Deferred Development Control Plan amendment - road pattern changes around Brighton and Bligh Streets, Riverstone

Item: DE3500 Report: DD360035 File: **DCP-15-420**

Council Meeting on 25 May 2016

REVIEW OF PROPOSED ROAD PATTERN AMENDMENT BRIGHTON STREET. RIVERSTONE

PROPOSED AMENDMENT TO BCC
GROWTH PRECINCTS DCP 2010

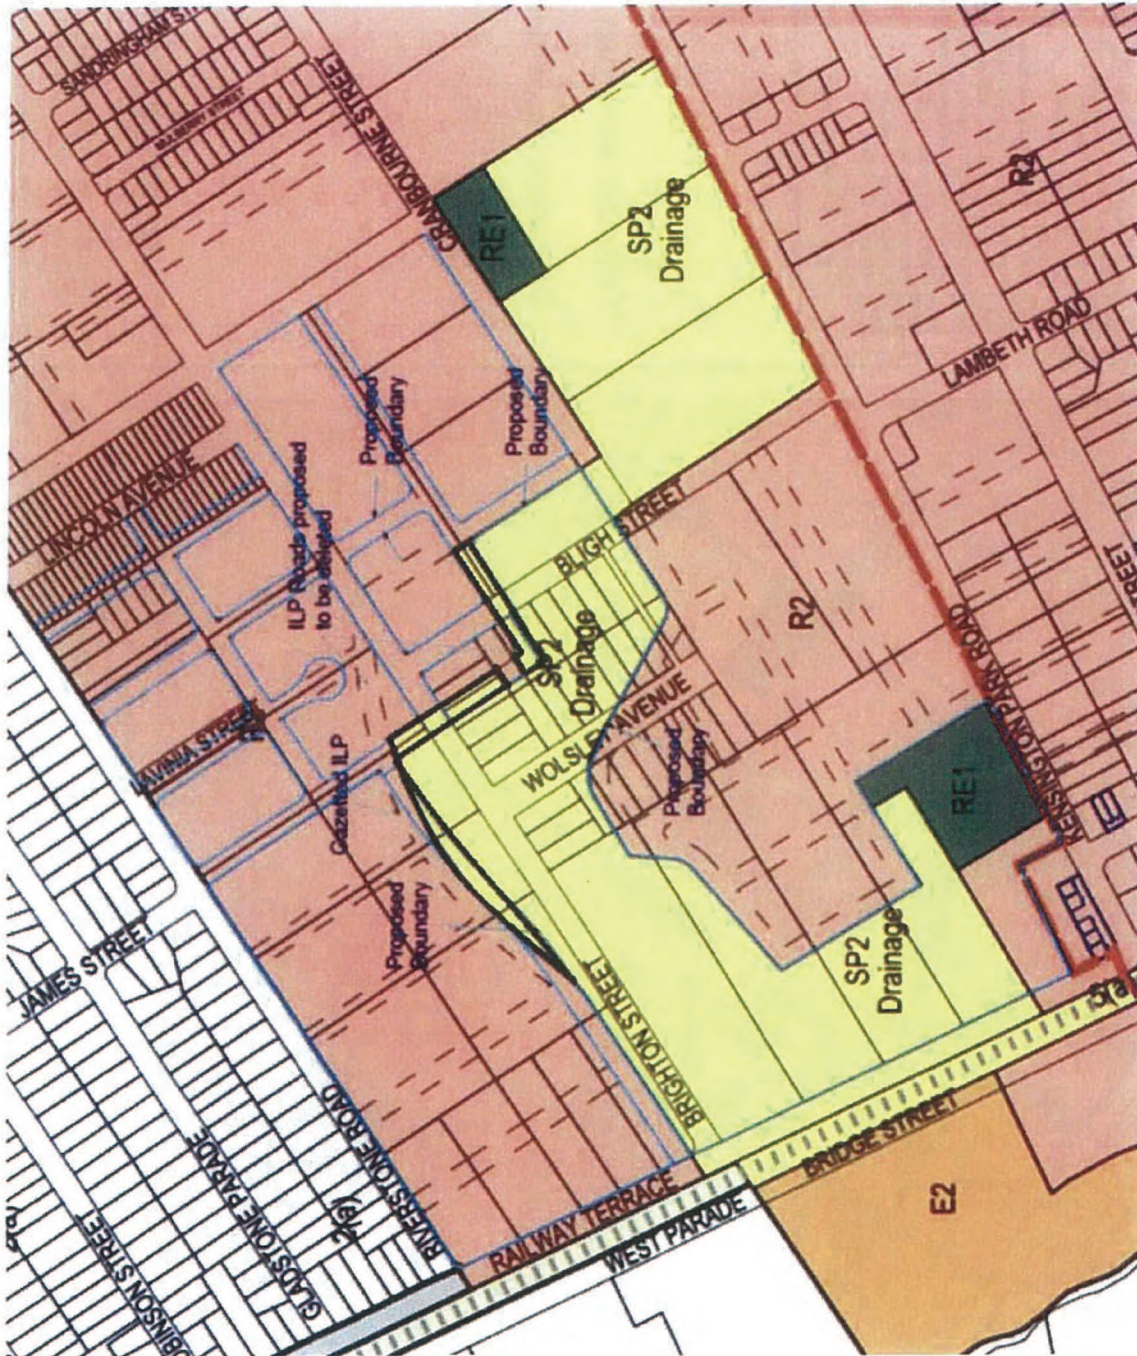
1. Support the amendment to the Blacktown City Council Growth Centre Precincts Development Control Plan (DCP) 2010 as shown on the plan at attachment 3.
2. Forward the amended draft Development Control Plan (DCP) to the Secretary of the Department of Planning and Environment at least 15 days before the DCP is made in accordance with the Instrument of Delegation given to Council.
3. Note that the DCP road pattern amendment will come into effect following publication of a notice in the local newspapers.
4. Prepare and forward a Planning Proposal to the Minister for Planning and Environment seeking a Gateway Determination to vary the zone boundary between the SP2 Infrastructure (Drainage) zone and the R2 Low Density Residential zone, as shown on the plan at attachment 4, to reflect the new DCP road pattern.

Figure 2 Proposed Amended Road Pattern

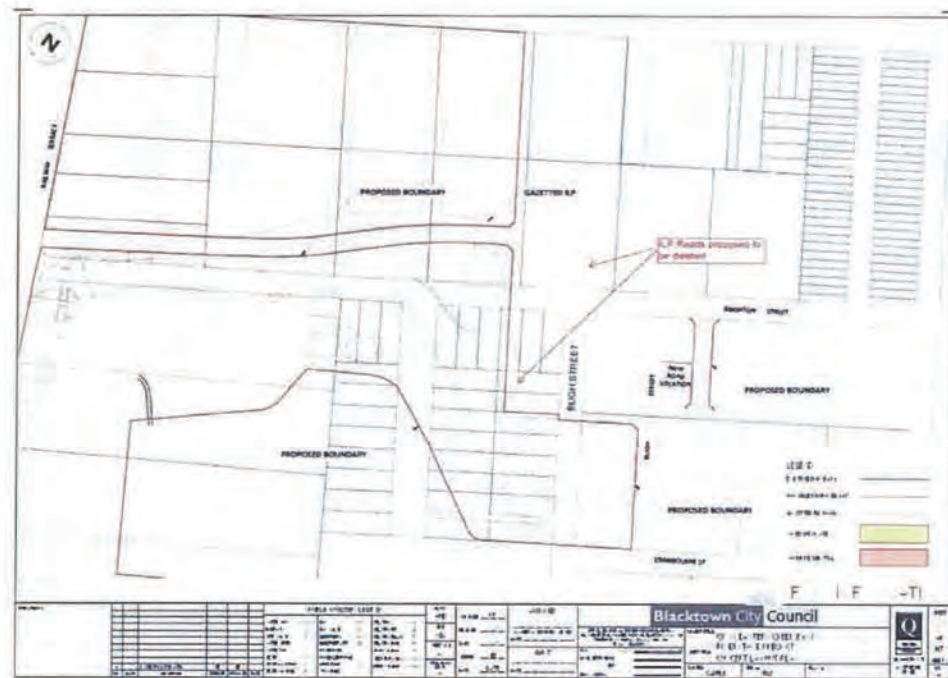
The following submissions against were received from nearby property owners. (Note: the numbers quoted relate to the numbers shown on Figure 2).

a. The ILP should retain and use the original alignment of Brighton Street, i.e. the way it was before the ILP shifted Brighton Street to the north when the rezoning of the Riverstone Precinct occurred under the Growth Centres State Environmental Planning Policy (SEPP) in 2010.

b. Although the exhibited plan may have merit, an alternative plan could be more sympathetic to existing residences and still achieve an equal or superior overall design outcome.

It is deemed from our own experience and expertise in road design that both the revised road design amendment of Brighton Street and the deletion and addition of minor roads shown in Figure 2 comply within the detail and intent of sound Engineering principles as well as the authoritative Austroad Design Guides.

The road layout has been reviewed alongside the objections received. The road layout has also been assessed in accordance with standard road design principles and in accordance with the requirements of the Austroad Guides. From a technical perspective the principles of traffic design have been applied appropriately to provide safe and manageable road system geometry in Councils proposed amendments.

Due to the levels and the required water course grades as well as the upstream and downstream effects it is inappropriate to retain the original Brighton Street alignment as a road. Brighton Street is after all a low point in this area and sections of Land adjacent are subject to flooding. The amended riparian and road layout will contribute a great deal to improving this situation dramatically. The ILP curved alignment is not considered appropriate and a 90° intersection is preferred. The relocation and deletion of the minor roads is also recommended for the reasons stated above. Final details of these can be confirmed, with development proposals for the land. An attempt has been made to provide an equal or superior design however the horizontal and vertical constraints lead back to the proposed amended road pattern.

Figure 5 : Proposed Amended Road Pattern with Riparian Zone Corridor

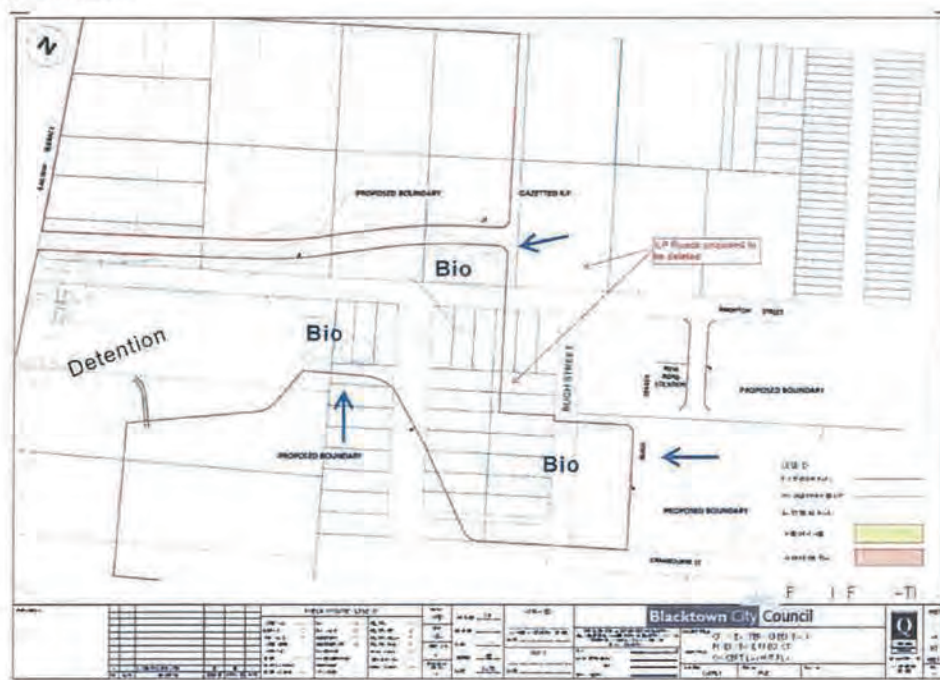
The resulting riparian zone corridor, stormwater detention basins and road network geometry are shown in Figure 4 below.

It has been noted that care is needed for the final design of the right hand corner of Brighton and Bligh Streets however this is a relatively minor design detail to be taken into account when detail design is undertaken.

Figure 2 Proposed Amended Road Pattern

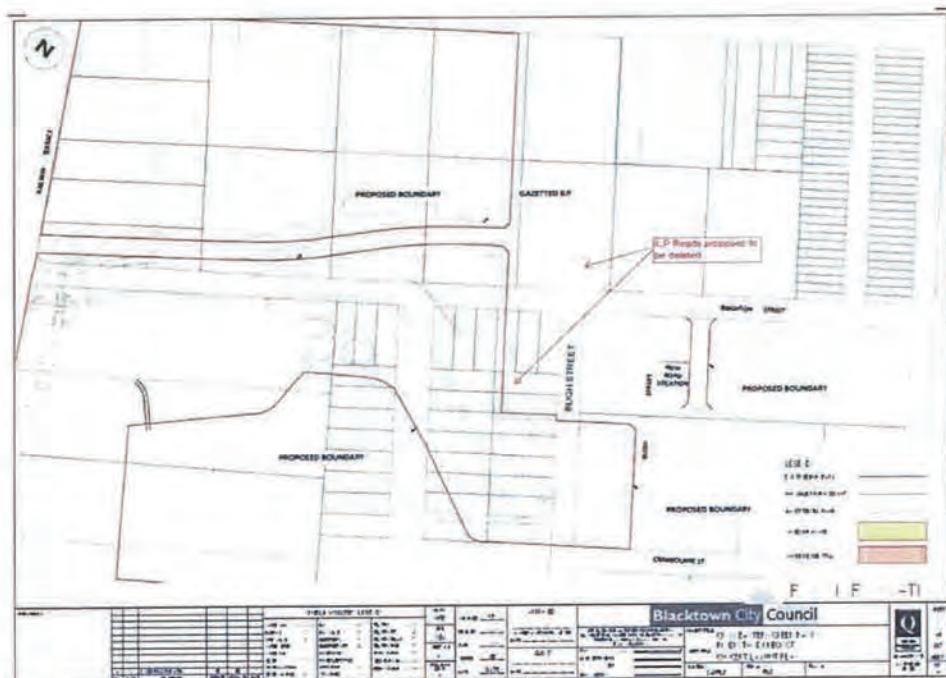
1. Supports DCP amendment
2. Objector - wants to retain existing Brighton Street alignment
3. Objector - concerned about new intersection on Brighton Street (impact on dwelling)
4. Supports DCP amendment

The following submissions against were received from nearby property owners. (Note: the numbers quoted relate to the numbers shown on Figure 2).

a. The ILP should retain and use the original alignment of Brighton Street, i.e. the way it was before the ILP shifted Brighton Street to the north when the rezoning of the Riverstone Precinct occurred under the Growth Centres State Environmental Planning Policy (SEPP) in 2010.

b. Although the exhibited plan may have merit, an alternative plan could be more sympathetic to existing residences and still achieve an equal or superior overall design outcome.

It is deemed from our own experience and expertise in road design that both the revised road design amendment of Brighton Street and the deletion and addition of minor roads shown in Figure 2 comply within the detail and intent of sound Engineering principles as well as the authoritative Austroad Design Guides.

Figure 5 : Proposed Amended Road Pattern with Riparian Zone Corridor

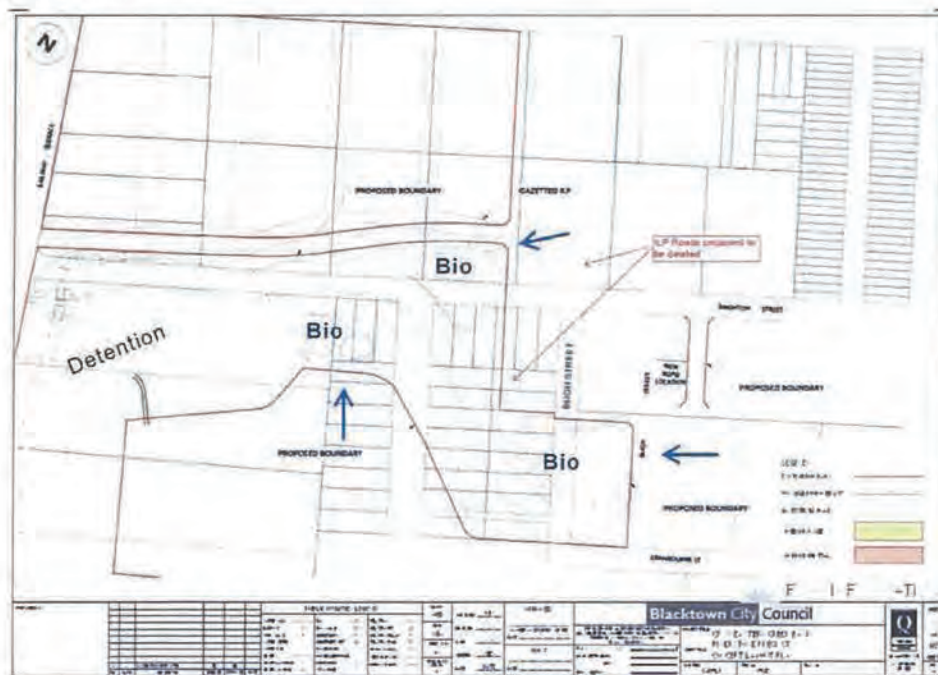
The resulting riparian zone corridor, stormwater detention basins and road network geometry are shown in Figure 4 below.
